Access Compliance Report Public Rights-of-Way (Pedestrian Signals)

Main Street: **ANTONIO_PKWY** Cross Street: **OSO_PKWY** Location: **W**

ADA ID: **SGRK211019122046** Signal Type: **One Push Button-APS** Overall Compliance: **No** Severity Scores: **BTN 1: 25** **BTN 2: N/A** **No BTN: N/A**

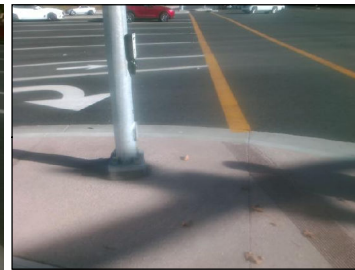
OC Std/PROW: **R404.2**

Possible Solutions: Remove and Replace Clear Space.
